SERVICE LETTER SL42 56-10113 Rev C

Subject: Replacement of existing aluminum hinges with newer, stainless hinges.

Part/Assembly No.: 56-10113-SUPP

Float Model Affected: 5850

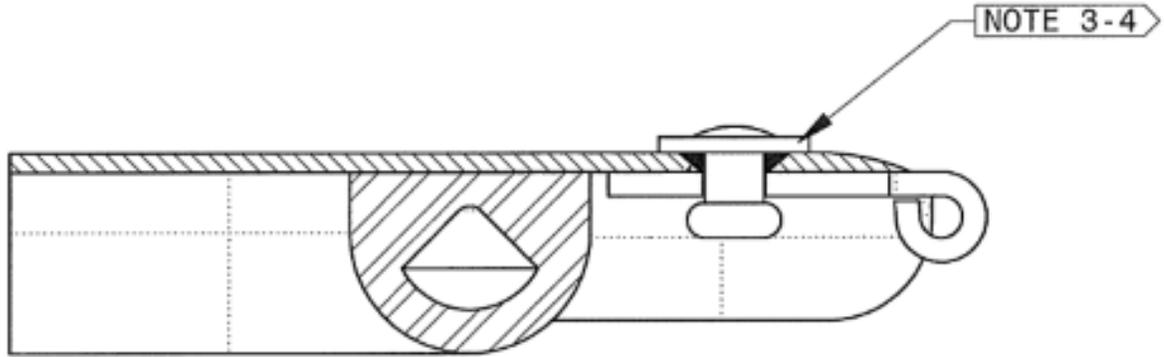
| Rev | Date | Page | Summary of Change | Authorized by |
|-----|------------|--------|--|---------------|
| C | 12/20/2021 | 5 §3.4 | Remove: Install MS16353 rivets with NAS1149CN416R washers beneath heads. Add: Install MS16535 rivets with NAS1149CN432R washers. | LM |

- 3.4 Install MS16535 rivets with NAS1149CN432R washers.
